Offshore Wind Farm

Outline Construction Traffic Management Plan (Clean)

Document Reference: 7.16
Volume: 7
Date: April 2025
Revision: 3

Drawing 104560-MMD-00-XX-DR-CE-1070_Rev01

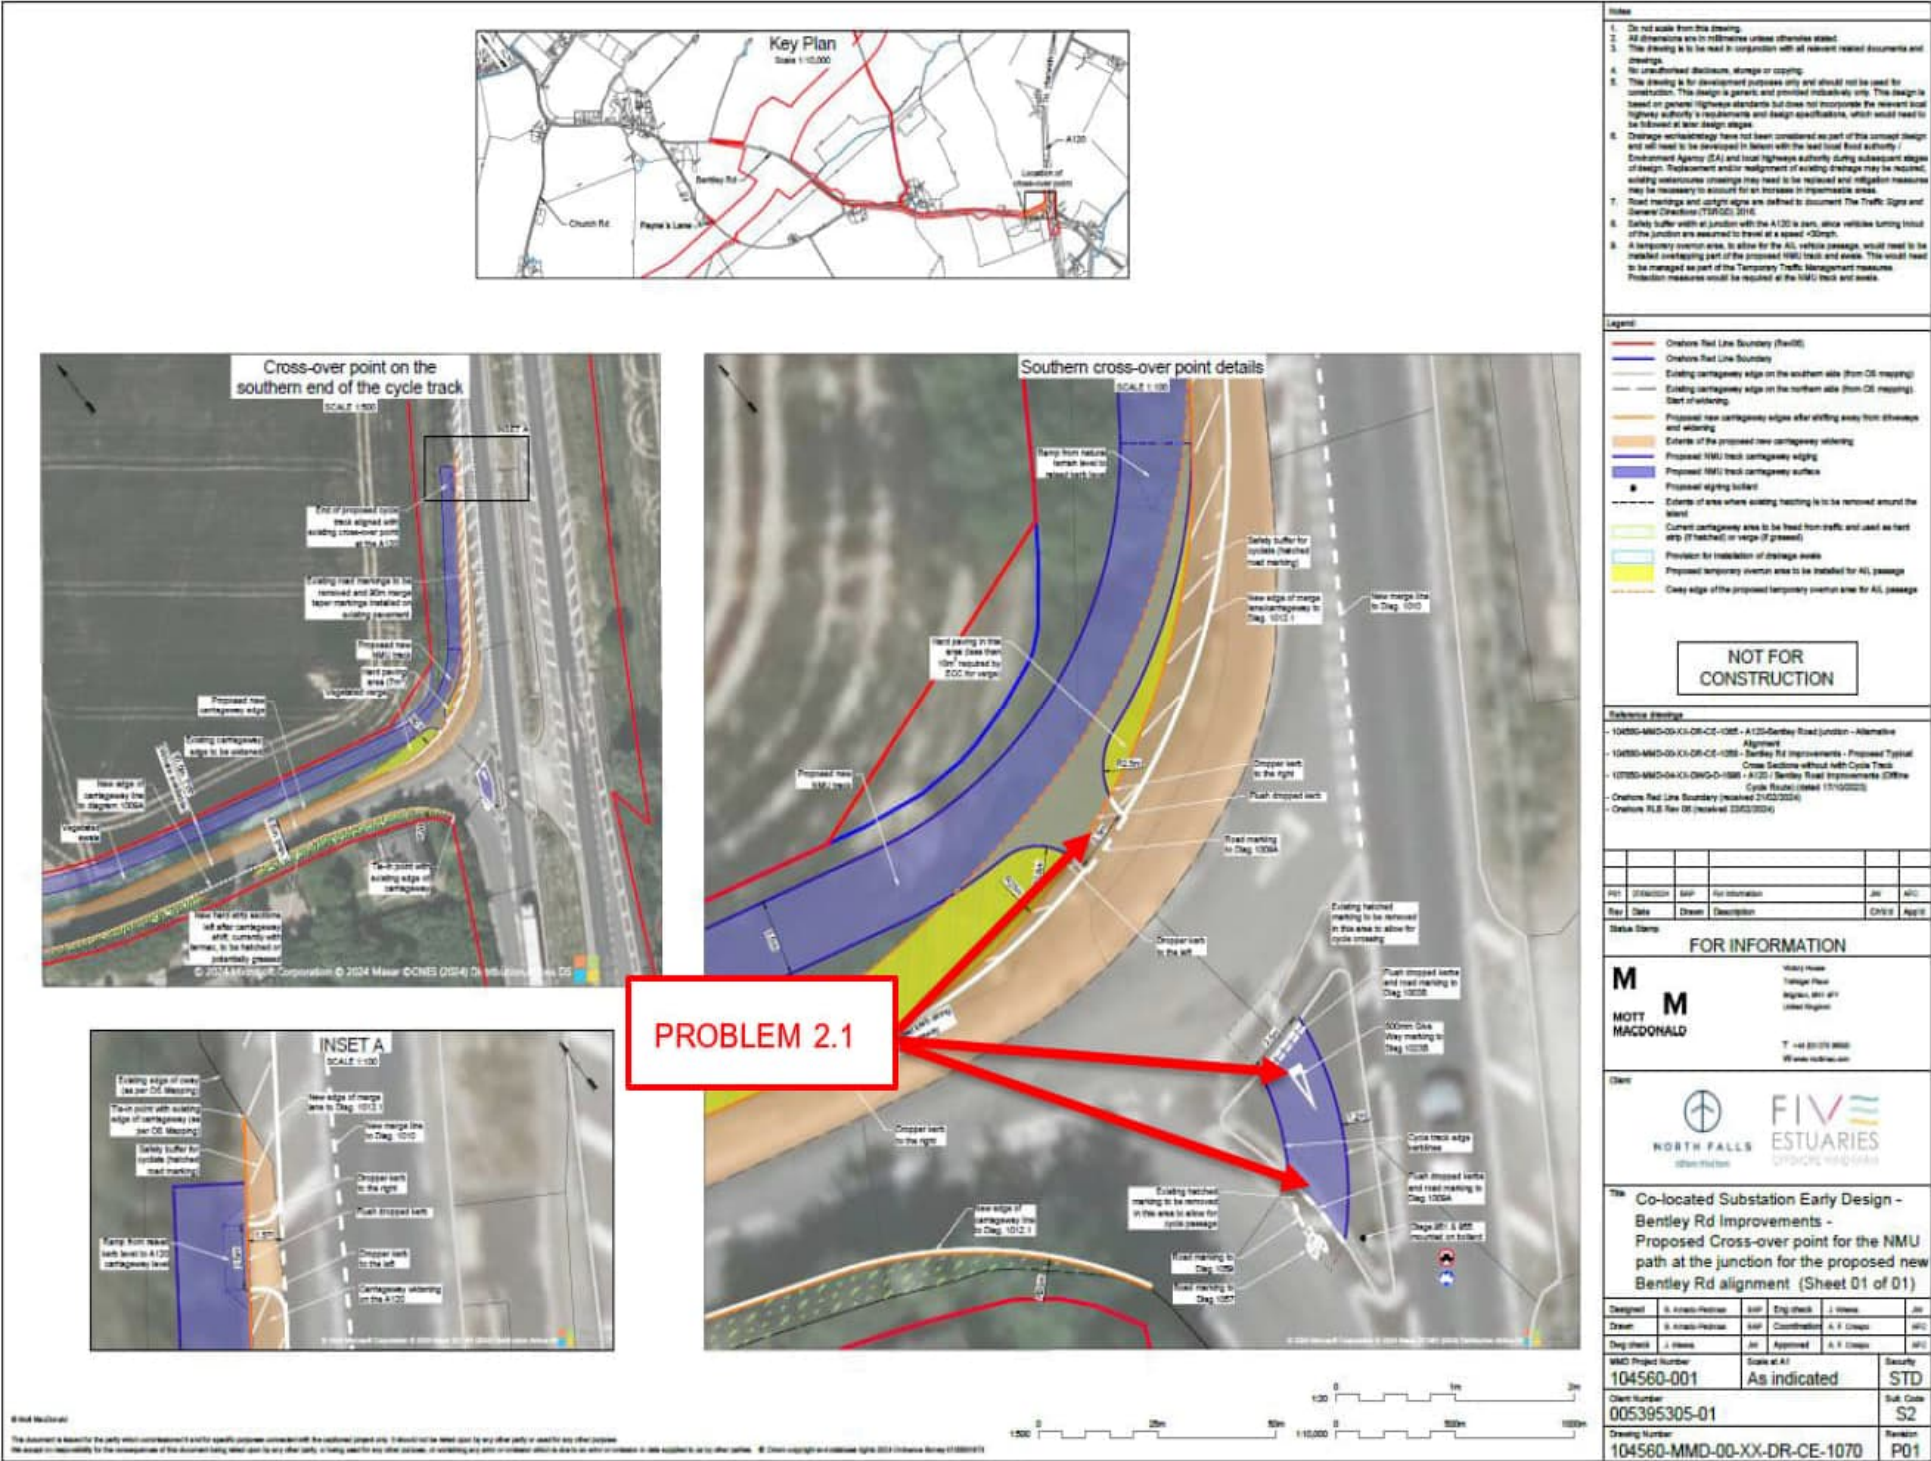
Drawing 104560-MMD-00-XX-DR-CE-1070_Rev01						
2.1	Location: A120/Bentley Rd Junction. Summary: Lack of hazard warning tactile paving provided at dropped kerbs leading to the NMU route may lead to collisions between NMUs and vehicular traffic. Design drawings show an extension of the NMU route adjacent to the A120. An existing splitter island will be amended with dropped kerbs and road markings to allow NMU users to leave the A120 Northwest bound. This design is not shown complete with hazard warning tactile paving that would alert NMUs particularly those with visual impairments that they are about to enter the vehicular carriageway. This arrangement may in turn lead to collisions between NMUs and vehicular traffic.	It is recommended that any access points to the vehicular carriageway are provided with the appropriate tactile paving installations.	● RSA problem acknowledged but recommendation partially dismissed due to the crossover movement only being allowed to northbound cycles and cycle access points to/from the carriageway not requiring the installation of tactile pavement. ● To provide greater clarity to the crossing movements allowed at this crossover point and to improve safety, both for pedestrians and cycles, a segregated shared use section of the NMU track is to be added along the area of concern to direct pedestrians away from the crossover. Tactile pavement is to be installed at the start and end of this segregated shared use section of the NMU track, in line with the Department for Transport document: <i>Guidance on the Use of Tactile Paving Surfaces</i>, Section 5. Ladder tactile pavement shall be installed at the start/end of the pedestrian way within the NMU track for a depth of 2.4m each, and width of 1.5m (width of the pedestrian way). Tramline tactile pavement shall be installed at the start/end of the cycle way within the NMU track for a depth of 2.4m each, and width of 2m (width of the cycle way). The ladder and tramline tactile pavement will assist vision impaired people. Diagrams 956 & 957 mounted on bollards and installed at the start/end of the segregated shared use section of the NMU track would also assist all other users. The installation of Diagrams 956 & 957 is a recommendation within <i>Guidance on the Use of Tactile Paving Surfaces</i>, Section 5 and LTN 1/20 paragraph 9.4.3, however their installation shall be discussed with the ECC LHA to avoid sign clutter. ● The segregated shared use NMU track will direct pedestrians away from the crossover point at the junction, greatly reducing the risk of pedestrians trying to cross. ● It is also proposed that the carriageway at the cycle area of the segregated shared use NMU track is surfaced in a different colour than the rest of the NMU track, to make it more conspicuous to all users. ● Additionally, the corner radii at the NMU track leg leading to the trafficked carriageway have been reduced to R=1m and the leg width, to 2.5m, except at the corner radii, to reduce comfort at making the turn. Edge of lane road markings have been proposed at the intersection of this leg with the NMU mainline cycle track and directional arrow road markings to emphasize the one-way character of this cycle track leg. ● This matter will be appraised further, in conjunction with the Local Highways Authority, as an integral part of the detailed design process, when bespoke signing and road marking drawings and specifications are to be agreed and produced for the preferred solution.	To be populated by the Audit Team	To be populated by the Client / Project Sponsor	This matter will be appraised further, in conjunction with the Local Highways Authority, as an integral part of the detailed design process, when bespoke signing and road marking drawings and specifications are to be produced for the agreed preferred solution. All measures to increase safety, described at the Design Organisation Response column, to be added to drawing 104560-MMD-00-XX-DR-CE-1070_Rev02.

Drawing 104560-MMD-00-XX-DR-CE-1066_Rev02

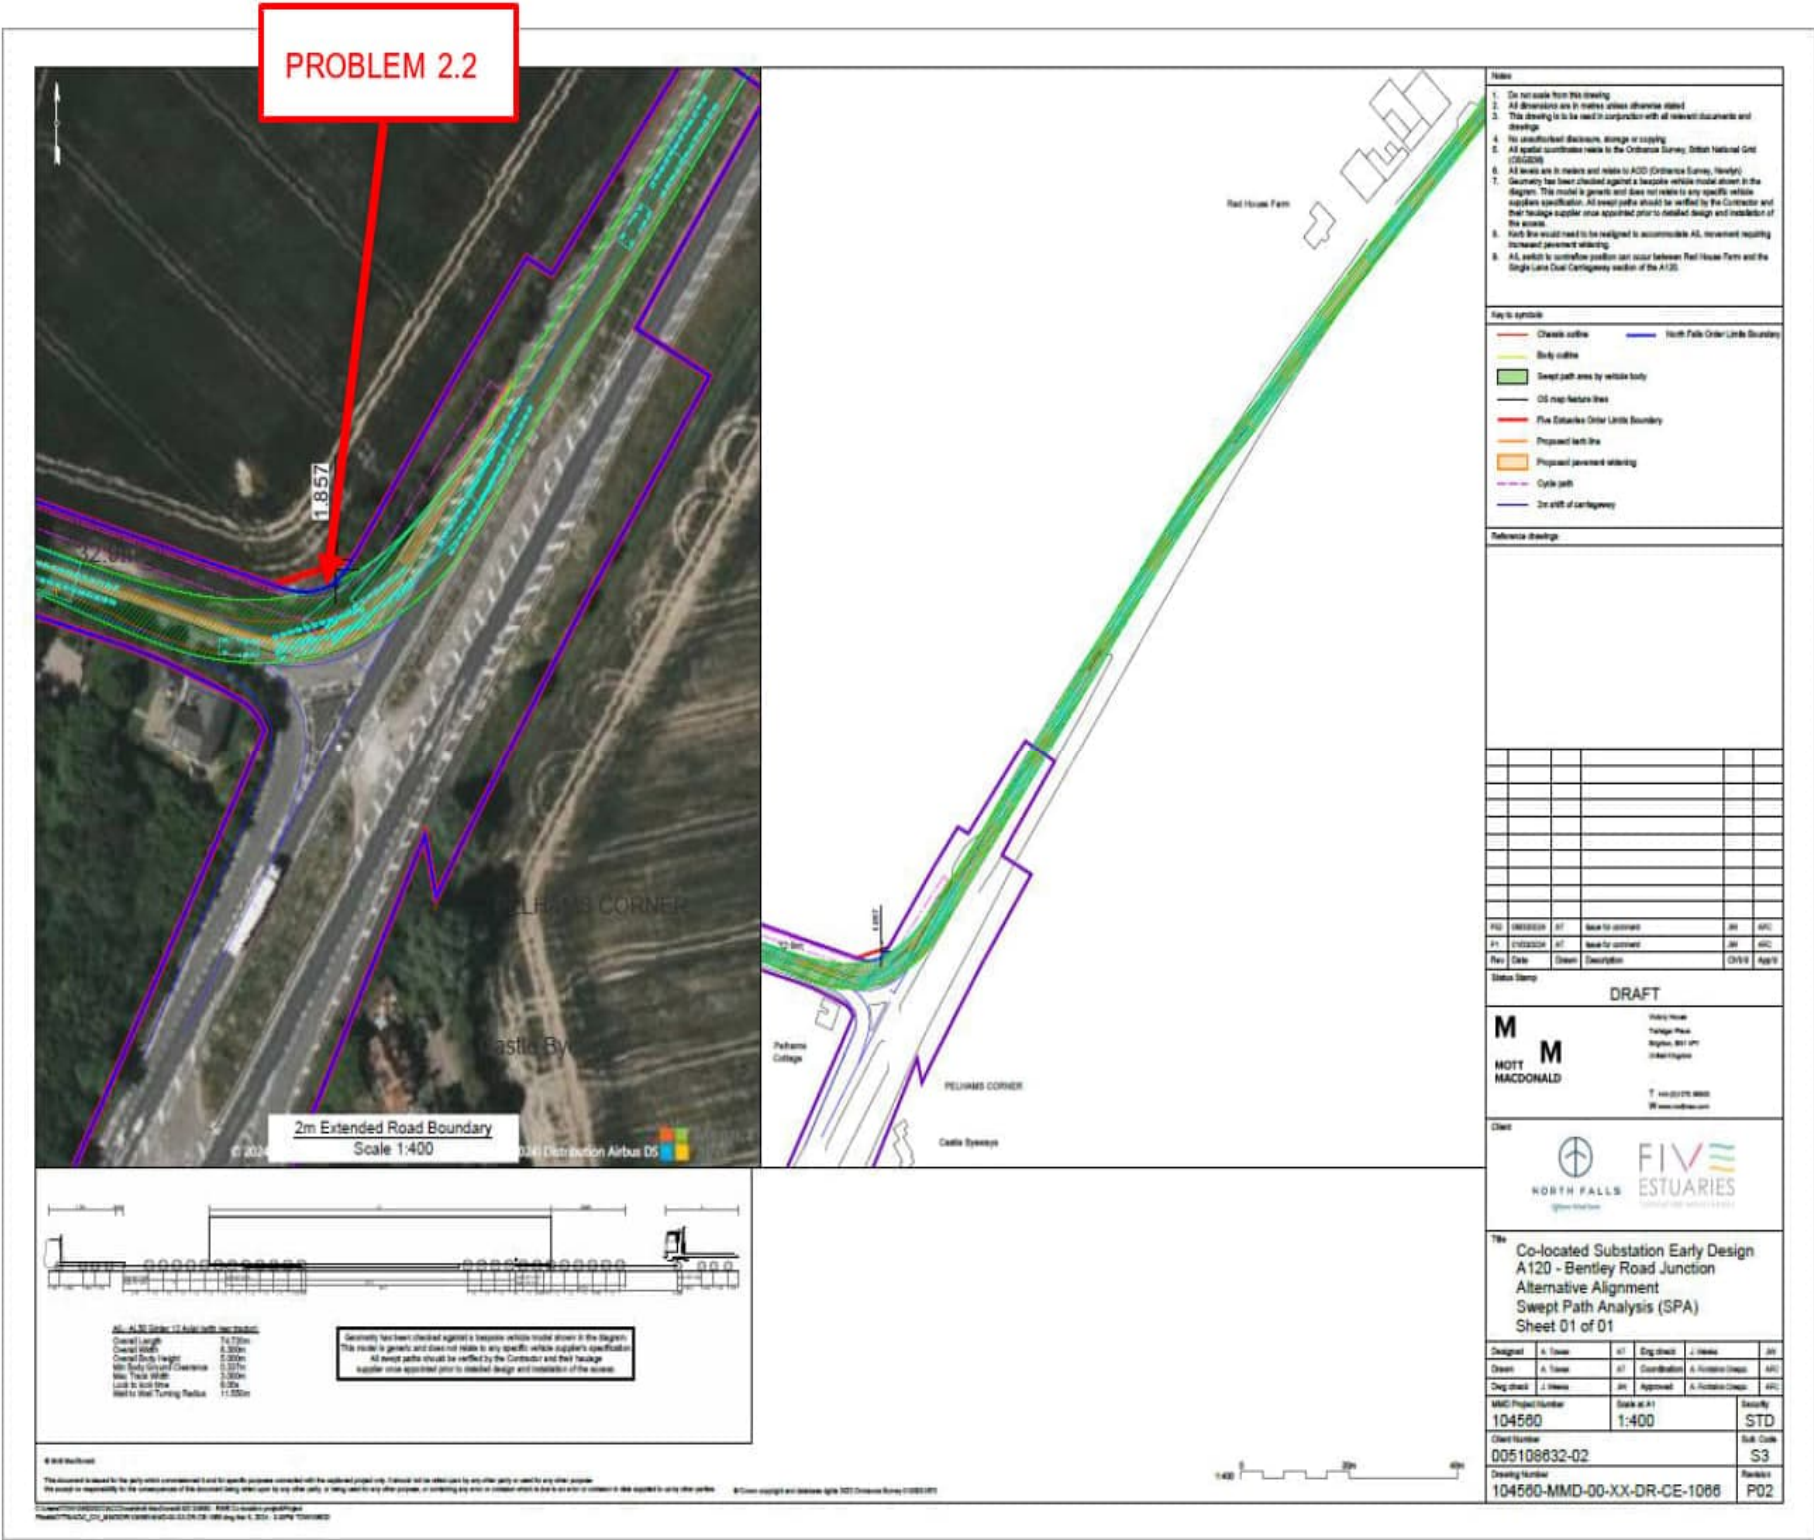
Drawing 104560-MMD-00-XX-DR-CE-1066_Rev02						
2.2	Location: A120/Bentley Rd Junction. Summary: Overrun of Exceptional 74.720m HGV into NMU corridor. Design drawings show swept path analysis of a multi axle drawbar HGV entering Bentley Road from the A120. The analysis drawing indicates that the body of this exceptional HGV will over sail the new NMU route as the vehicle turns from the A120 onto Bentley Road. This	It is recommended that banks persons are used where HGVs are required to make turns along the route to ensure that pedestrians and vulnerable road users are separated from large vehicle turning movements.	● RSA problem acknowledged and recommendation agreed. ● The use of banks persons is implicit within the Temporary Traffic Management measures to be agreed with the Local Highways Authority. These TTM measures shall be detailed at a later stage of the project. ● A note specifying the use of banks persons shall be added to drawing 104560-MMD-00-XX-DR-CE-1066_Rev03 for clarity.	To be populated by the Audit Team	To be populated by the Client / Project Sponsor	A note specifying the use of banks persons shall be added to drawing 104560-MMD-00-XX-DR-CE-1066_Rev03 for clarity. TTM measures shall be detailed and agreed with the LHA at a later stage of the project.
